#### NOTICE OF A REGULAR MEETING BONDURANT PLANNING AND ZONING COMMISSION AUGUST 8, 2019

## PLANNING AND ZONING COMMISSION RESOLUTION NO. PZ-190808-17

BONDURANT, IOWA 89 PAINE STREET SE SITE PLAN REVIEW COMMENTS

#### 89 Paine Street SE Site Plan First Submittal

## EROSION AND SEDIMENT CONTROL PLAN

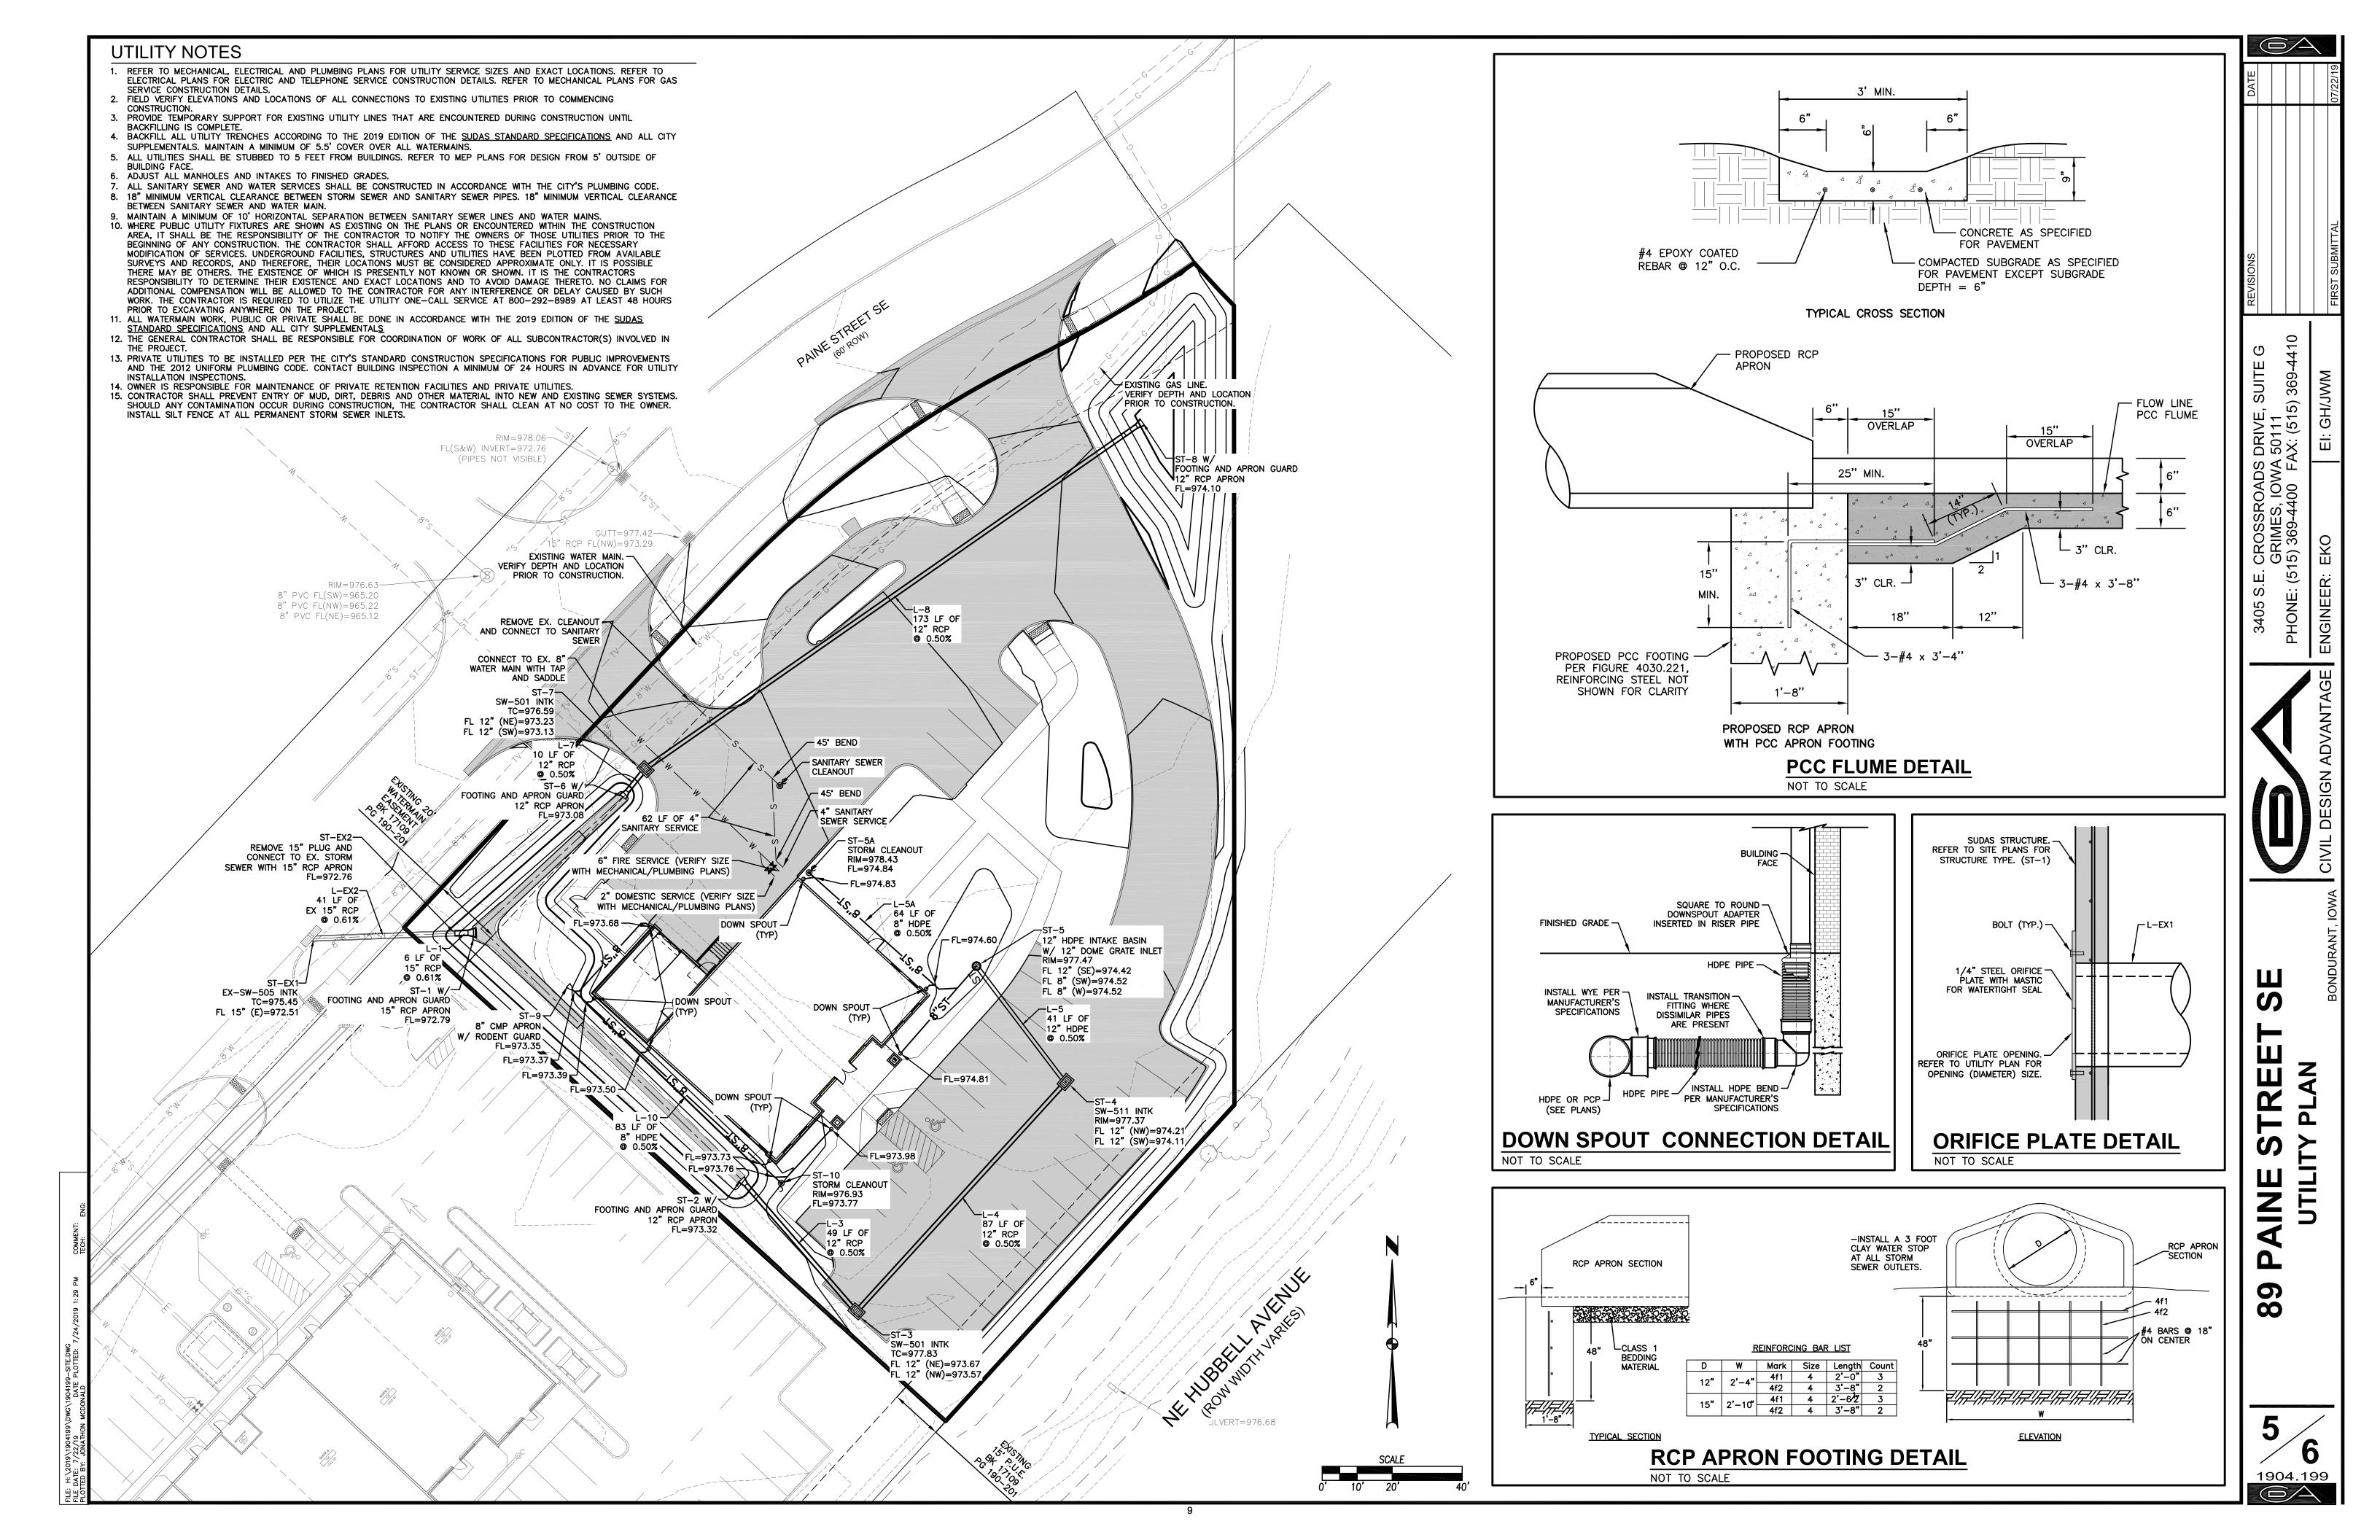
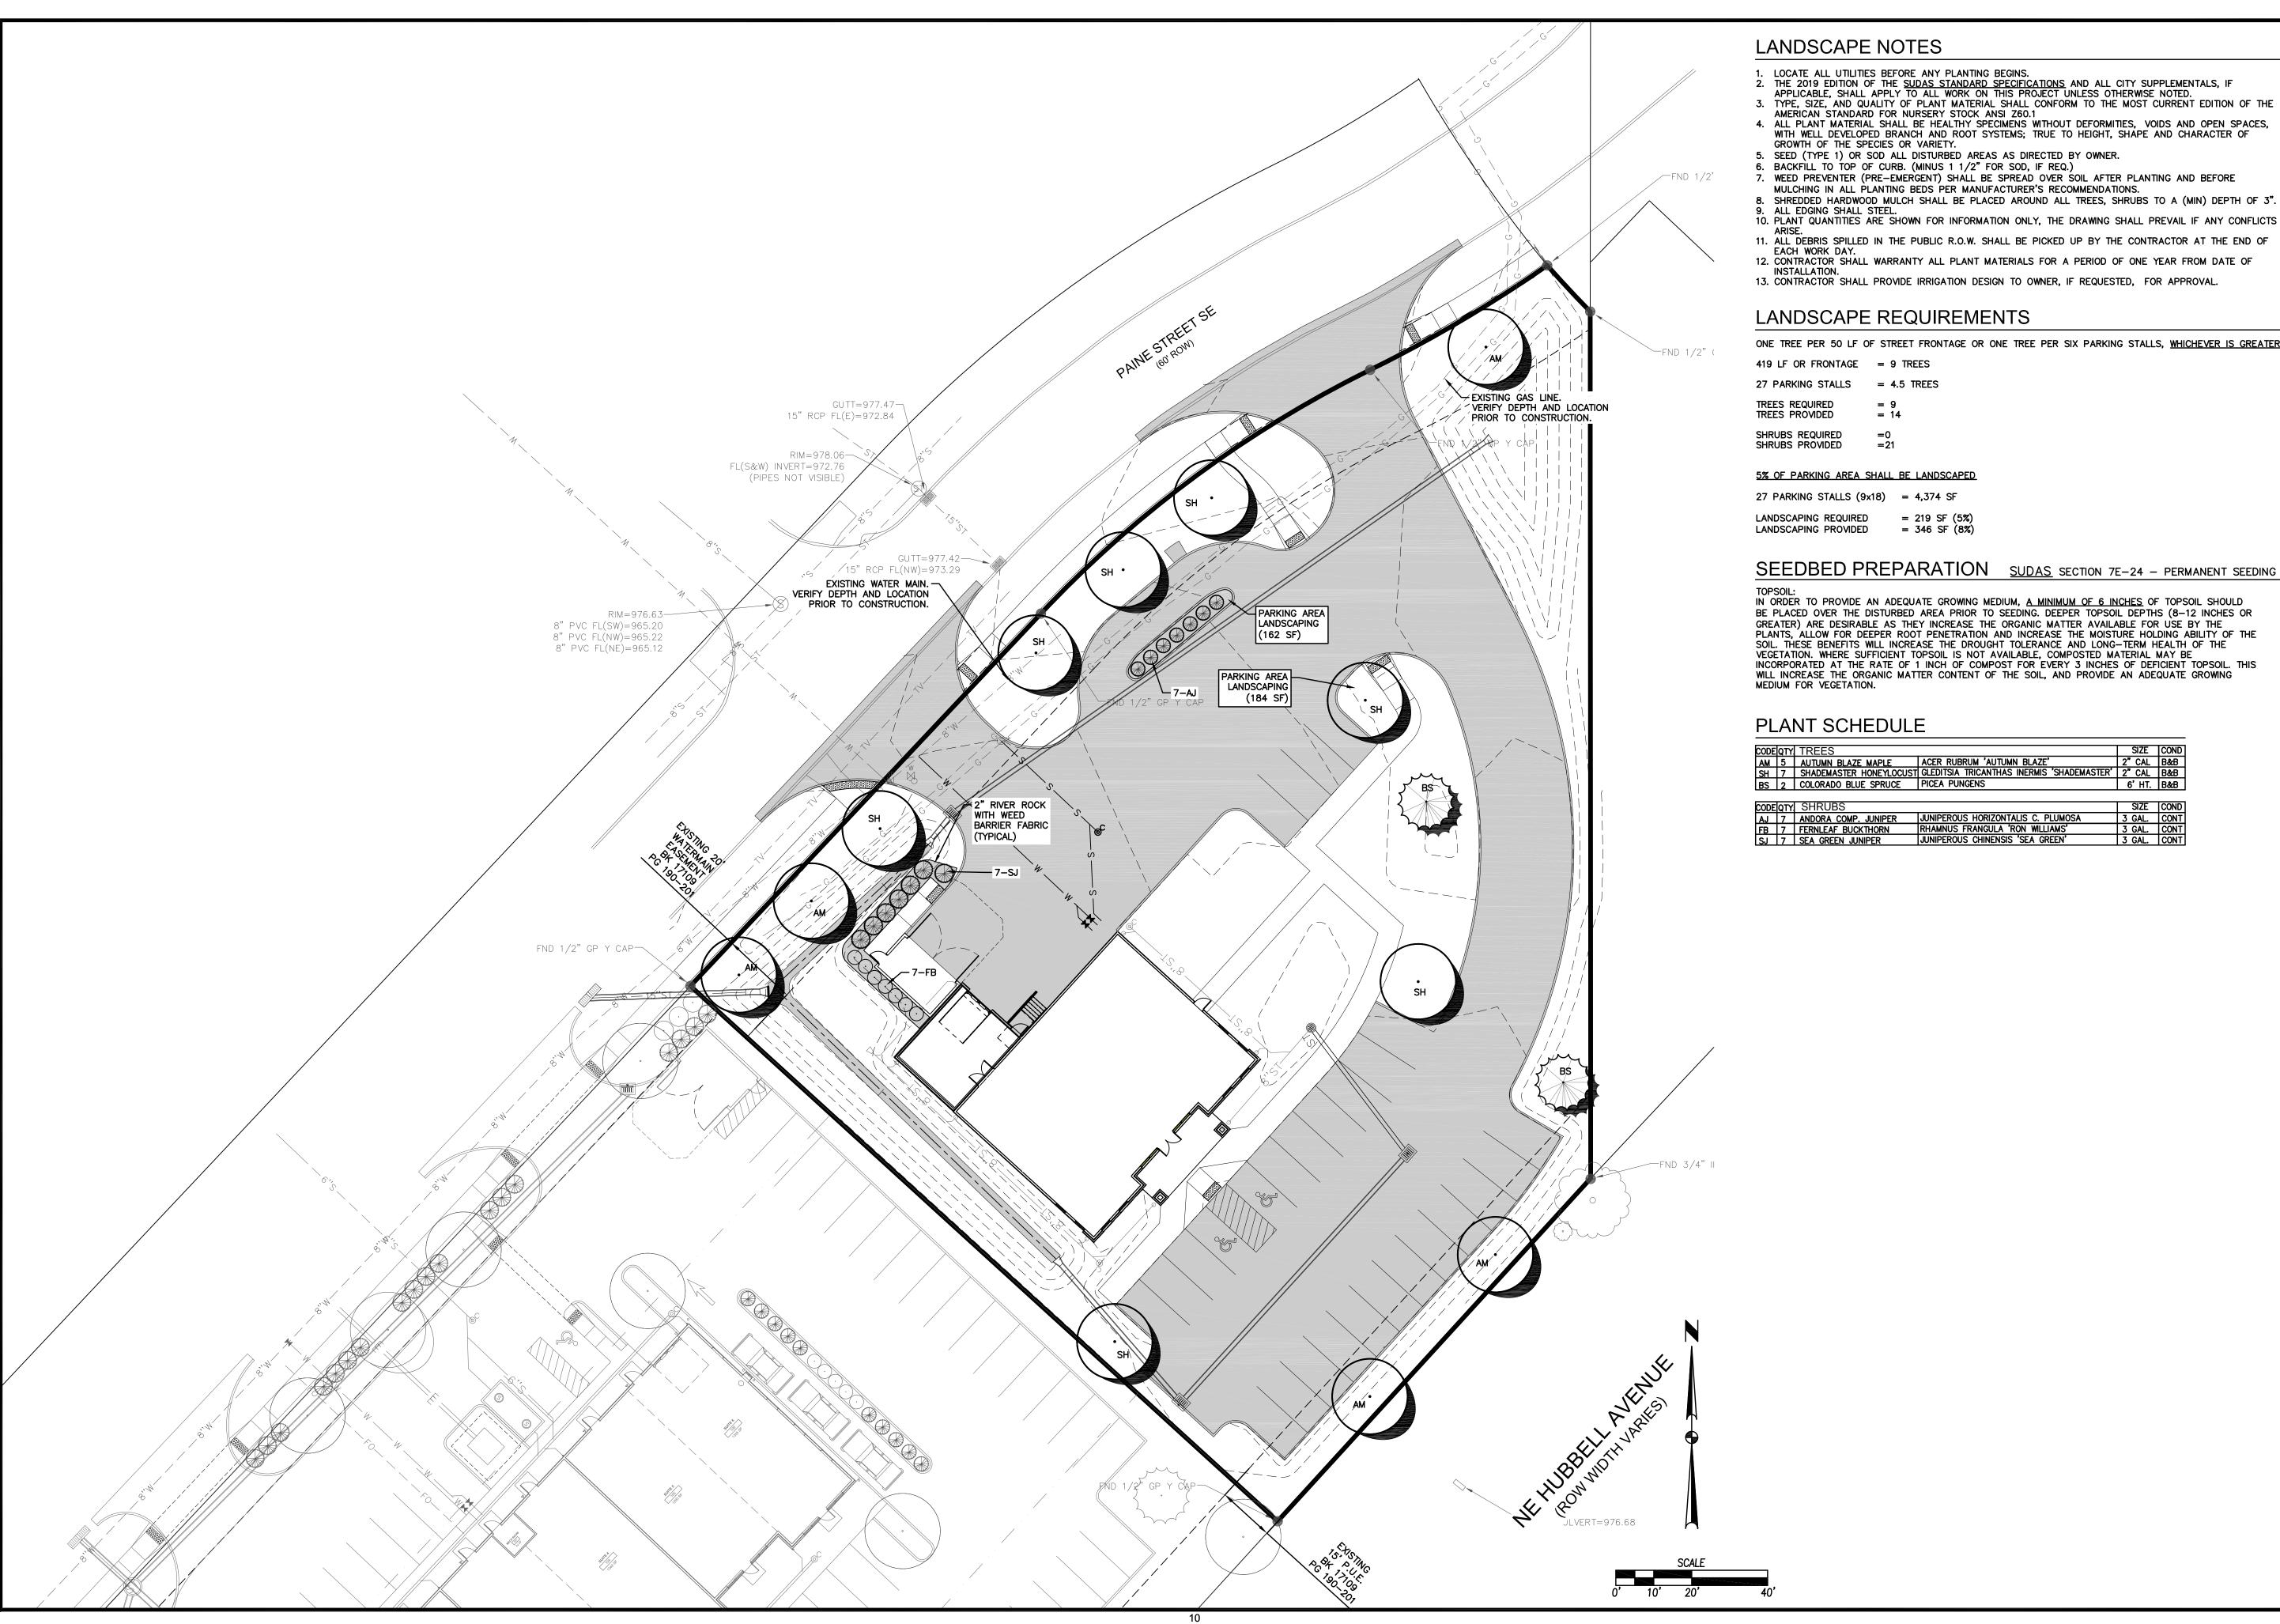
- 15. The site plan includes sidewalk access both to the northeasterly and southeasterly faces of the new building.
- 16. The site plan includes an erosion control plan. The site will disturb more than one acre. The applicant will need to obtain a General Permit No. 2 from the Iowa Department of Natural Resources. A copy of the Storm Water Pollution Prevention Plan and the General Permit No. 2 will need to be provided to the City prior to the start of construction.

DB 1

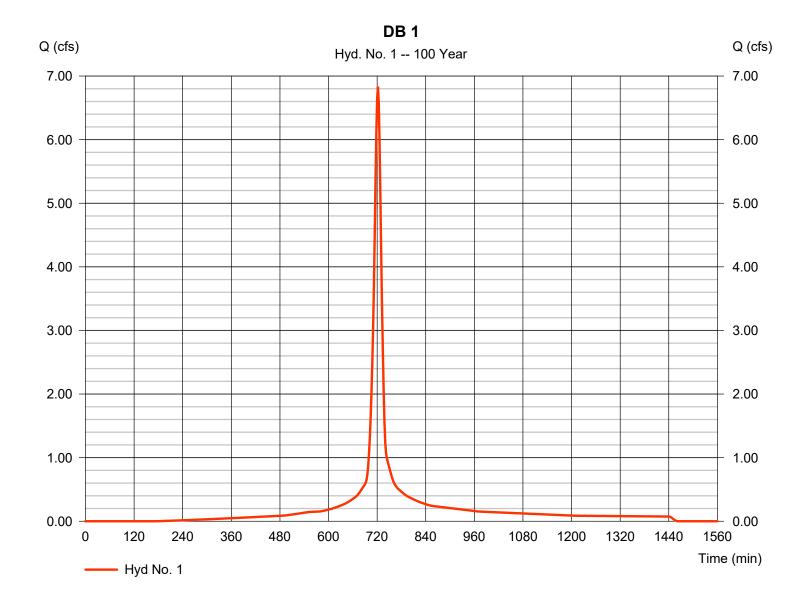
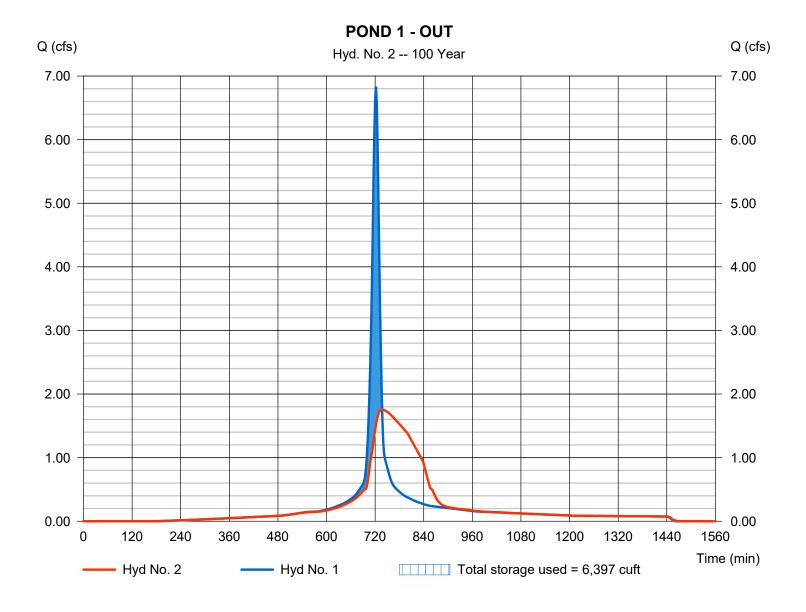
- 28. The City generally prefers a 1-foot freeboard. For this site the freeboard provided is 0.28 feet. In this instance the combination of the assumed time of concentration of 15 minutes and the freeboard of 0.28 feet increases the potential for overtopping of the basin in a major rainfall event. Given the potential for overtopping the applicant will need to provide additional information on the flow path in the event of an overtopping of the basin to document any overtopping flow does not adversely impact adjoining properties.

- 29. The stormwater management plan indicates that the peak runoff from a 100 year developed condition event for the detained area would be 6.833 cfs.
